SERVICE INSTRUCTION

AMENDMENT ON REDUCTION GEARBOX TYPE „C“ AND TYPE „E“ FOR ROTAX® 2-STROKE UL AIRCRAFT ENGINES

SI-06-1998

Amendment on reduction gearbox type „C“ and type „E“ for 2-stroke UL aircraft engines.

Fig. 1, 2 and 3

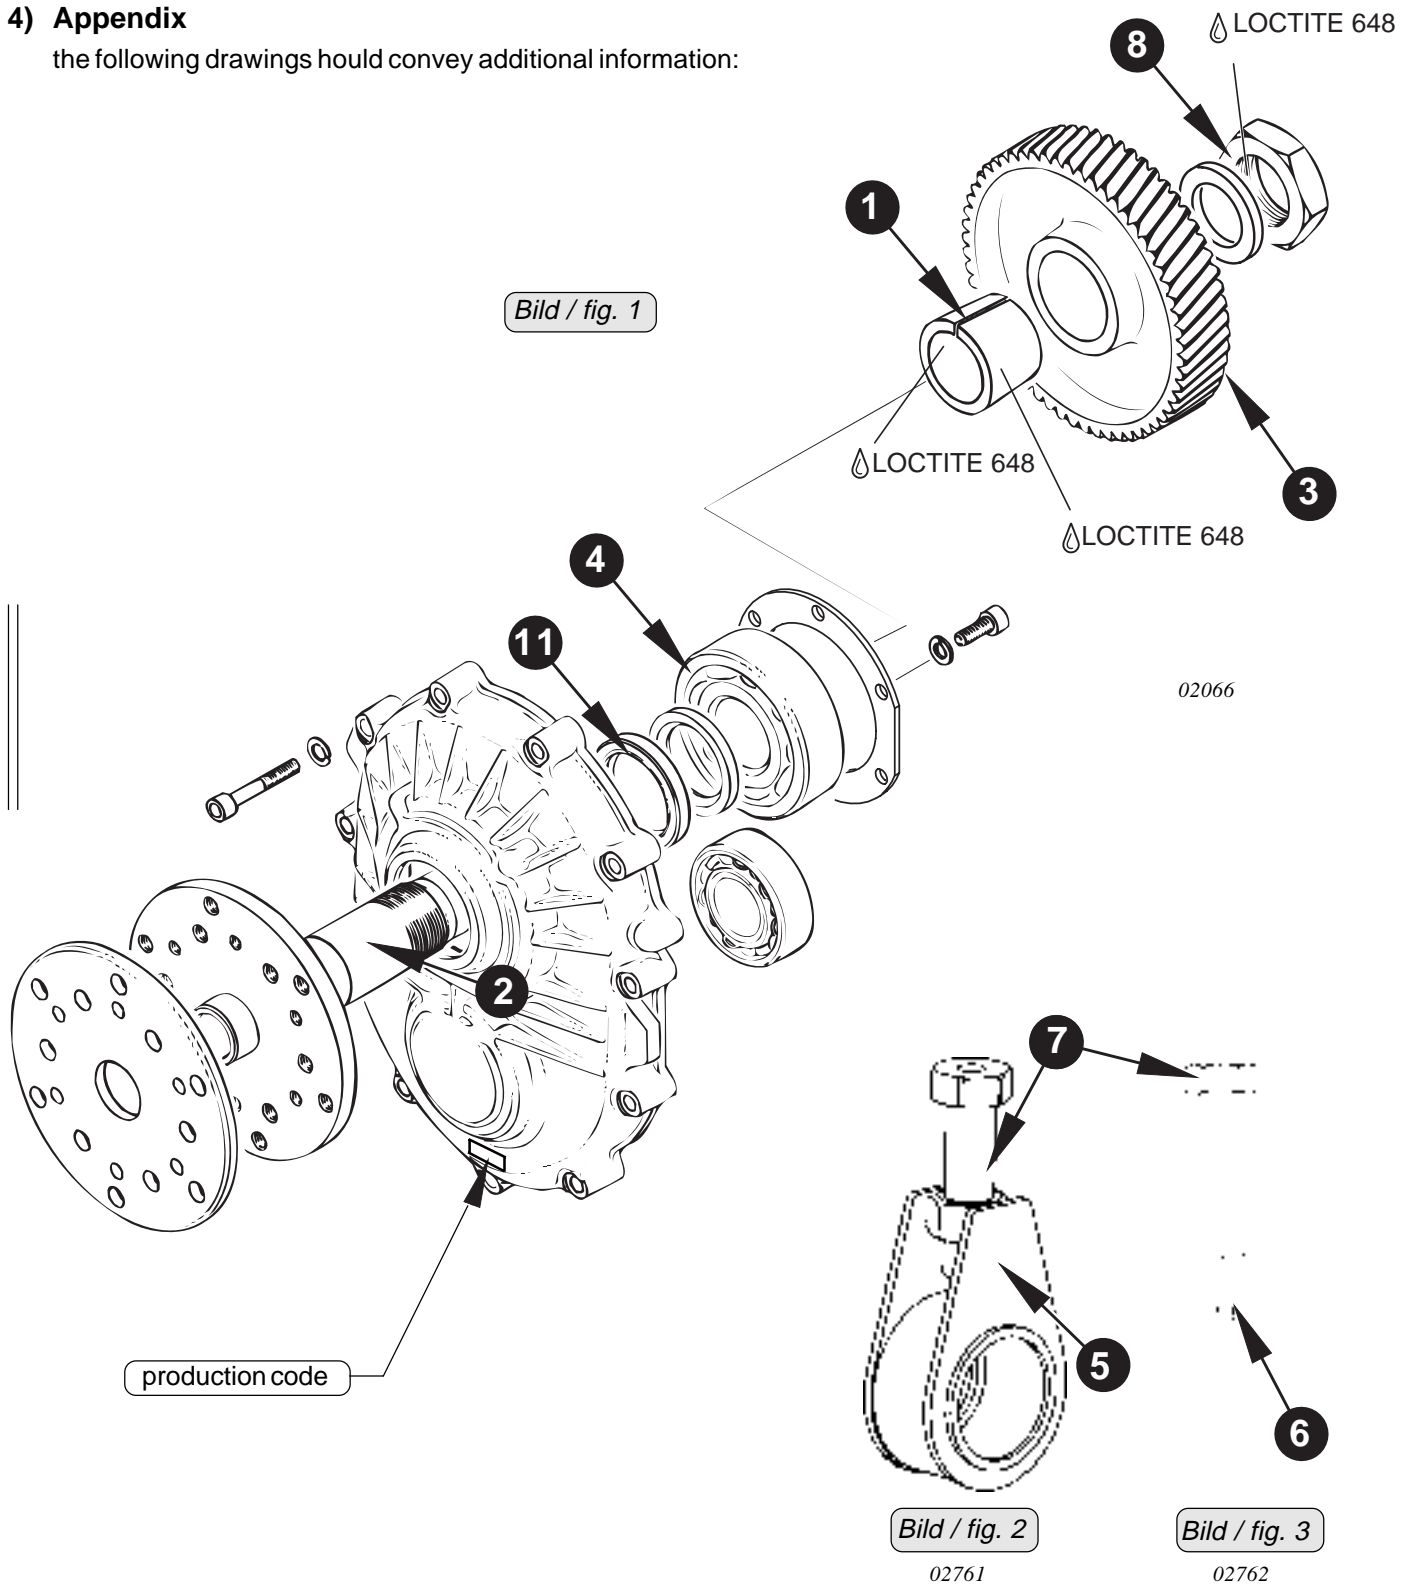
- Place cone sleeve (1) into installation sleeve assy (5). Make sure that the rotating shaft (6) of the pressure screw (7) comes to rest in the slot of the cone sleeve (1).

- Using a spanner move shaft (6) into slot until the cone sleeve (1) expands enough.
- CAUTION: But ensure that the shaft will not move beyond inside dia. of the sleeve. Otherwise you risk damage to the propeller shaft.

- Apply LOCTITE 648 on inside of cone sleeve (1).
- ▲ WARNING: Make absolutely sure that no LOCTITE will enter into the ball bearing (4).
- After placing cone sleeve (1) into position on propeller shaft slacken the pressure screw (7) and remove the tool.

- Apply LOCTITE 648 on outside of cone sleeve (1).
- The tightening torque of the hex. nut (8) has been newly specified to **250 ±10 Nm (185 ±7 ft.lb)**.

view: puller assy
Fig. 4 and 5

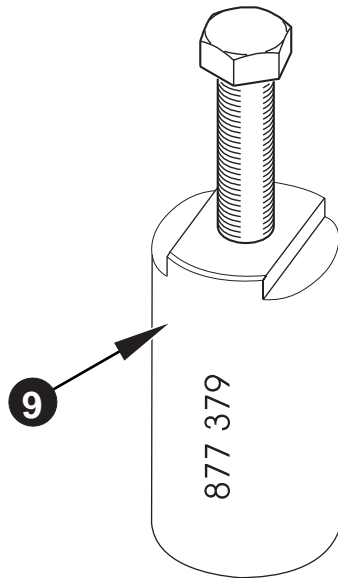
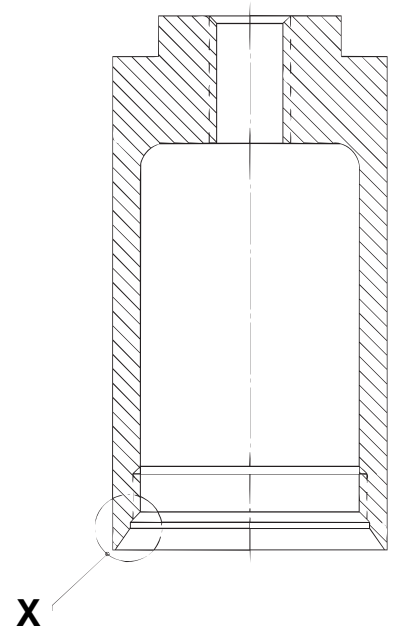
Because of the changed assembly procedure the puller (9) for the layshaft gear has been modified. The new tool is fashioned with a chamfering at the base of the puller (9), thus achieving the best stability at pulling-off procedure. Furthermore the other end of the puller is now flat sided 36 A/F to tighten the puller (9) into position.

- Place the mushroom-shaped protection piece (10) part no. 877 415 into the centering of the propeller shaft (2).
- Preheat the layshaft gear (3) (gluing area) with a hot air gun to approximately 300°C (570°F) to reverse the glue effect.

- CAUTION: Hot components risk of injury.
- Fit the puller assy. (9) part no. 877 379 on layshaft gear and tighten with open and wrench 36 A/F.
- Screw-in and tighten the puller screw. Remove propeller shaft assy complete with gear cover and puller assy from the fixture. If necessary separate the layshaft gear by a blow of the hammer on the tightened puller screw.
